## 30' Front Wing Swivels

For Models- 30'

Swivels Affected

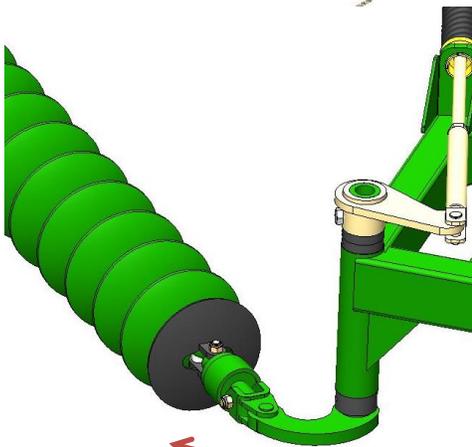
It has come to our attention that 30' machines, when stored outside and exposed to rain and snow, may have bearings which become waterlogged and fail prematurely (the swivels affected are shown above). If the machine is likely to be left exposed to these conditions it is recommended that the bearing be removed, and replaced with the seal facing downwards whilst in the transport position, similar to the opposite swivel on the outer wing. This will prevent water ingress during storage and thus extend the life of the swivel.
